# ENVIRONMENTAL REVIEW TEAM REPORT

**CEDAR  
MOUNTAIN ROAD  
DEVELOPMENT

THOMASTON,  
CONNECTICUT**

APRIL 1986

**SURFICIAL  
GEOLOGY**

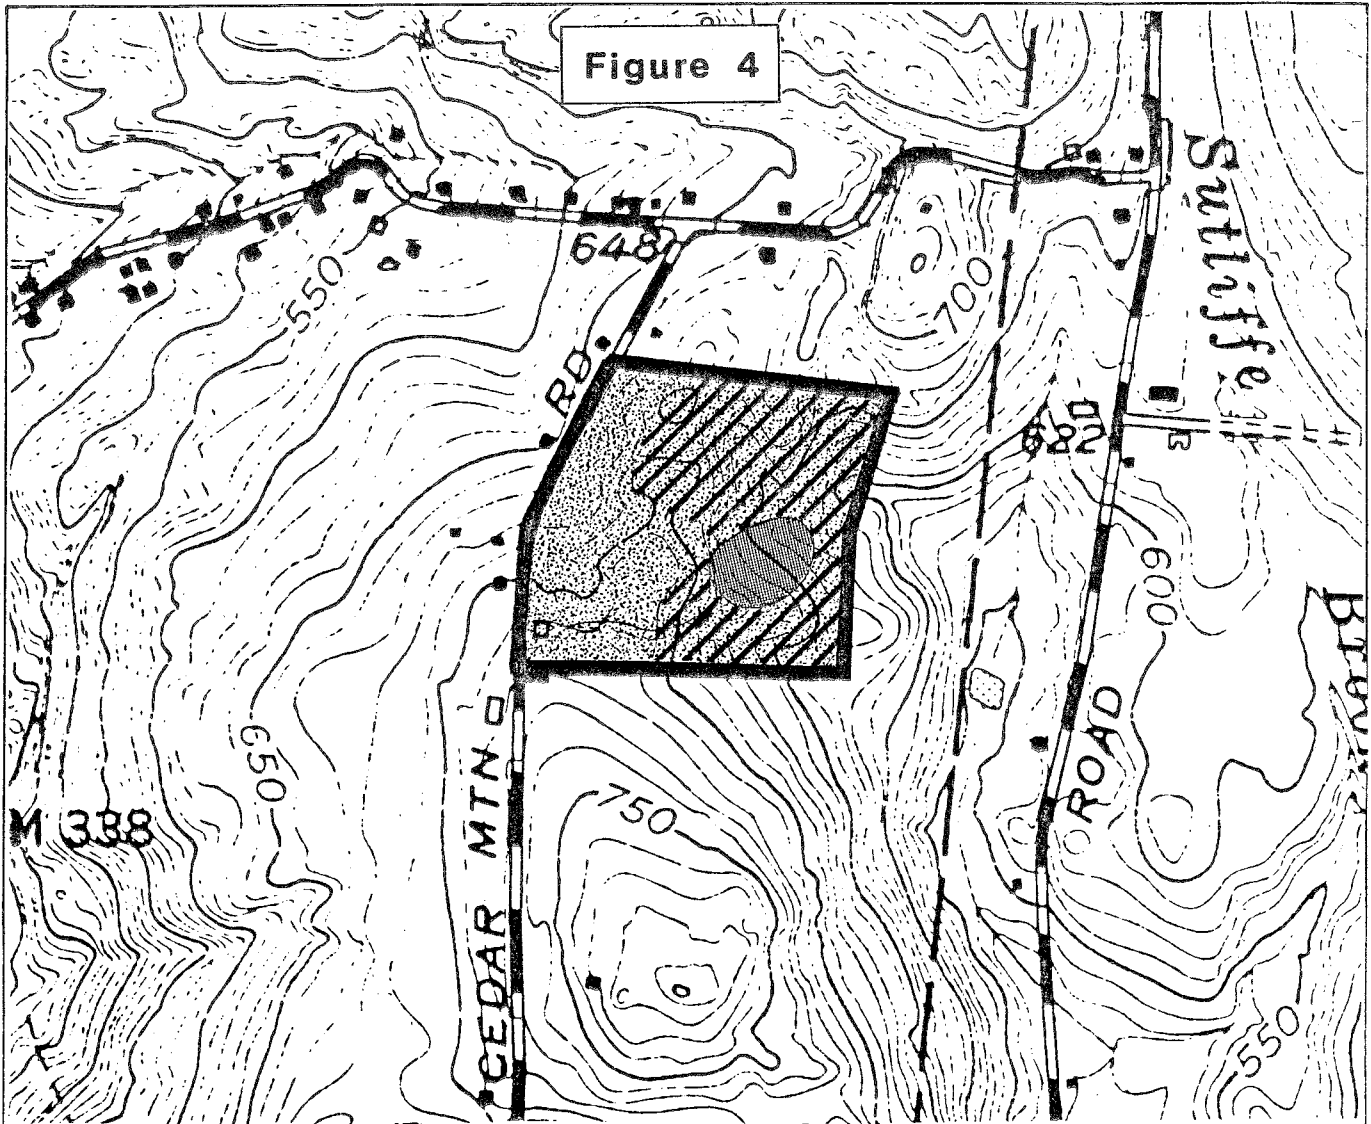
redeposited directly from the ice, either by being plastered onto the land from beneath the ice mass, or by being let down gently as the ice melted. The resulting deposit was till. Because of its mode of deposition, till contains a non-sorted mixture of particles ranging in size from clay to large boulders. The till may be sandy, stony and loose, or silty, less stony and tightly compact. Based on mapped soil information, the latter variety of till comprises the western sections of the parcel. The thickness of the till in this area may very well exceed 10 feet. Till in the central and eastern portions is relatively shallow (e.g., probably less than five feet), and is generally loose (Figure 4).

For approximately six years (1960-1966), a privately-owned landfill was operated in the southeast corner of the site. The exact volume of refuse disposed of in the landfill is unknown. According to information supplied to Team members, refuse disposed of in the landfill consisted of garbage, combustible and non-combustible rubbish, abandoned vehicles, and industrial wastes.

**WATERSHED  
BOUNDARY**

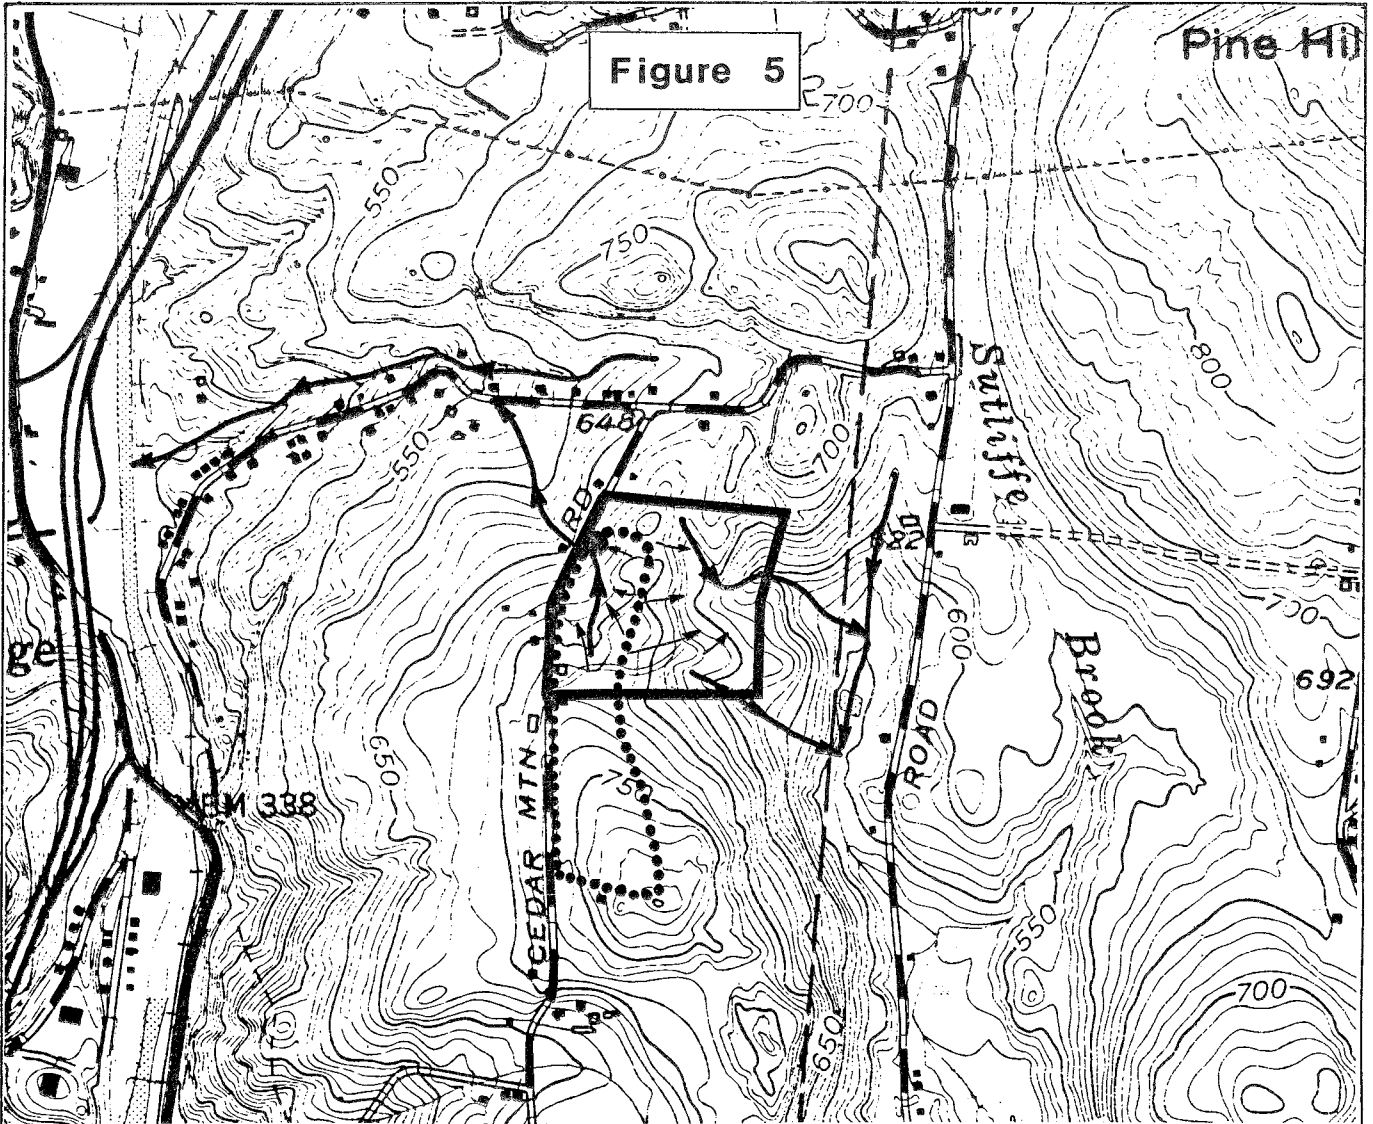
The effect of increased runoff to the culvert passing under Cedar Mountain Road may now be analyzed. The watershed area analyzed for the peak flows is shown in Figure 5. It is based upon a certain point of outflow (i.e., culvert passing under Cedar Mountain Road), and shows all of the land from which runoff ultimately reaches that point.

As mentioned earlier, TR-55 techniques were used in the analysis to determine peak flow. Several factors which ordinarily would be incorporated into the calculations were not included (i.e., piping), because no final site plan has been devised to date. Nevertheless, the results of the peak flow calculations should prove useful as "ball park" guides to anticipated peak flow increases. As indicated in Table 2, the calculated peak flow increases (based on the aforementioned assumptions) are moderately high (about 14 percent for the 10, 25 and 100 year storm events). These increases may be of particular concern to the Town, especially in view of the 12-inch pipe passing under Cedar Mountain Road. The pipe may be too small to handle increased flows due to additional development in the watershed during certain storm events. As a result flooding problems could arise in this area. Therefore, if development occurs on the parcel, the project engineer should take a close look at this culvert.

It is suggested that once the applicant submits a plan for the site, that he/she be required to submit detailed hydrological information on pre- and postdevelopment runoff volumes and peak flows from the site. Estimates should be provided for the 2, 10, and 100 year design storms. Detailed design information on how the applicant plans to handle increased flow from the site should also be submitted for town review.

**DISTRIBUTION  
OF SOILS**

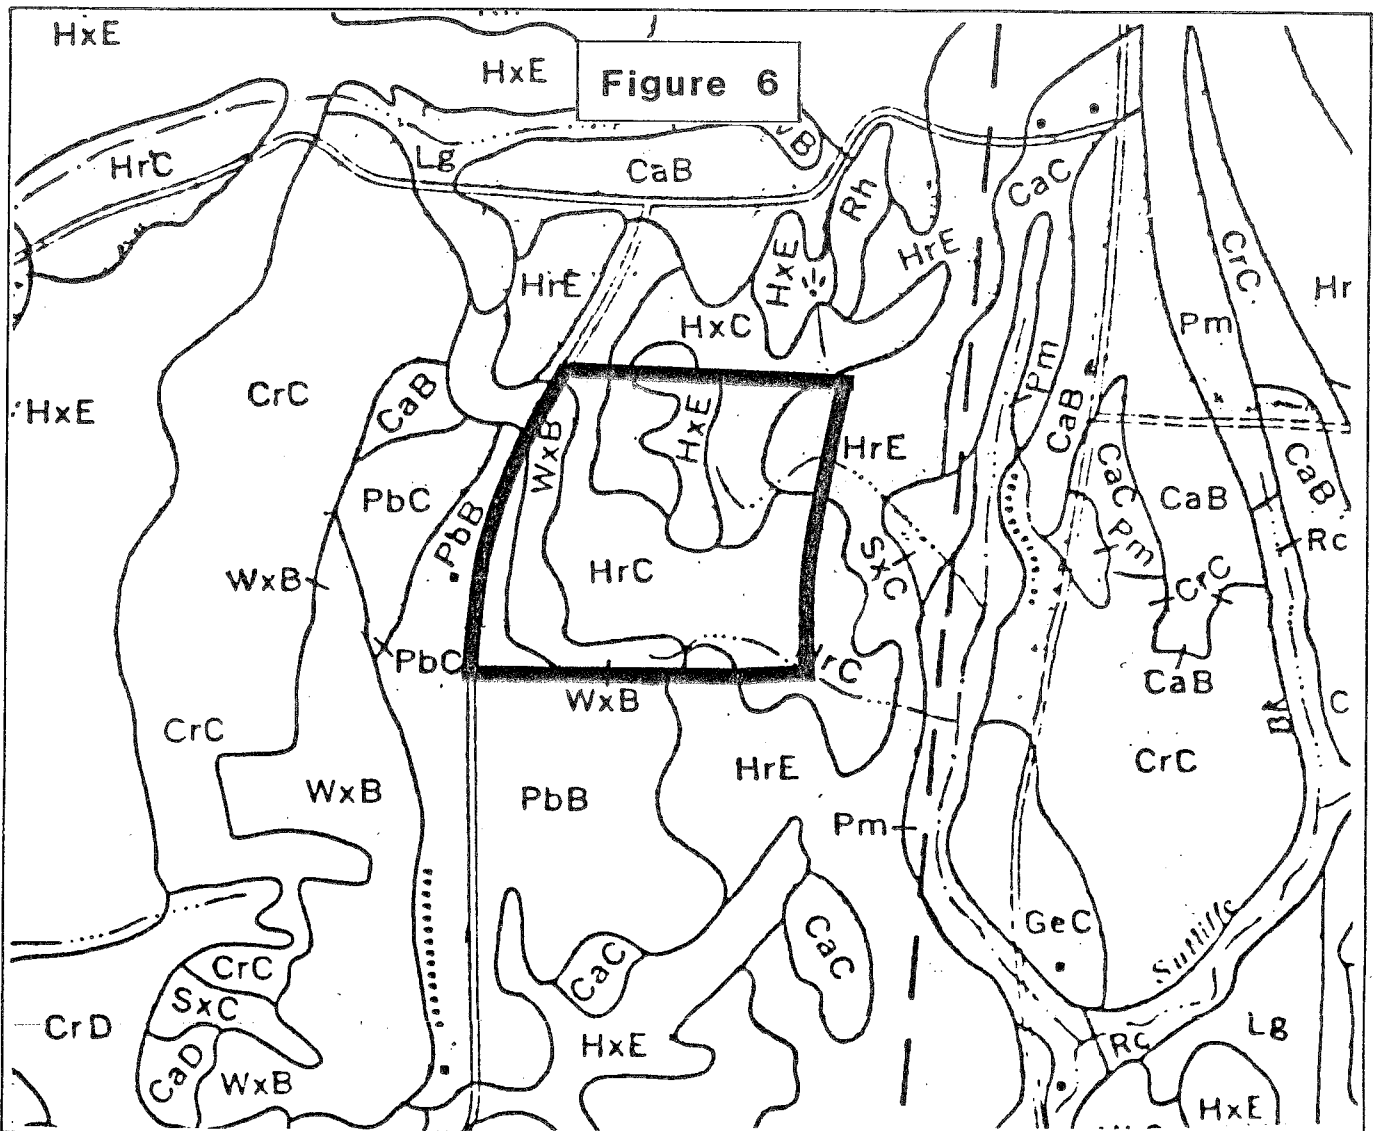
The proposed 29-acre development on Cedar Mountain Road comprises mostly of Hollis soil types. There are also Paxton and Woodbridge soils located on the site. These two soils as well as Hollis are derived from glacial till. The former landfill in the southeast section of the study area has disturbed some soils (Figure 6).

The Hollis soils have considerable severe limitations regarding housing developments due to the shallow to bedrock nature of the soil. A possibility could exist that small inclusions of Charlton soils may be found in the Hollis soil area. This particular soil is most often suitable for development as well as septic systems. A public service or private soil scientist should be consulted to determine that possibility. The soil scientist can also determine the extent of the landfill area as well as the hazardous chemicals disposed of there.

The Paxton and Woodbridge soils found along Cedar Mountain Road are more suited to development. They are also considered prime farmland soils. However, due to the hardpan nature of the soils, care must be taken when developing the site. Proper drainage would be needed due to the high water table during the wet times of the year. Also, since the soil slopes towards the road, it is suggested that the septic systems be placed toward the road. Private wells should be placed 75 feet apart to avoid potential pollution from a possible septic failure. This will also conform to Torrington Area Health District standards.

Test pits on the property will also determine the amount of suitable building lots that can be divided from the property.
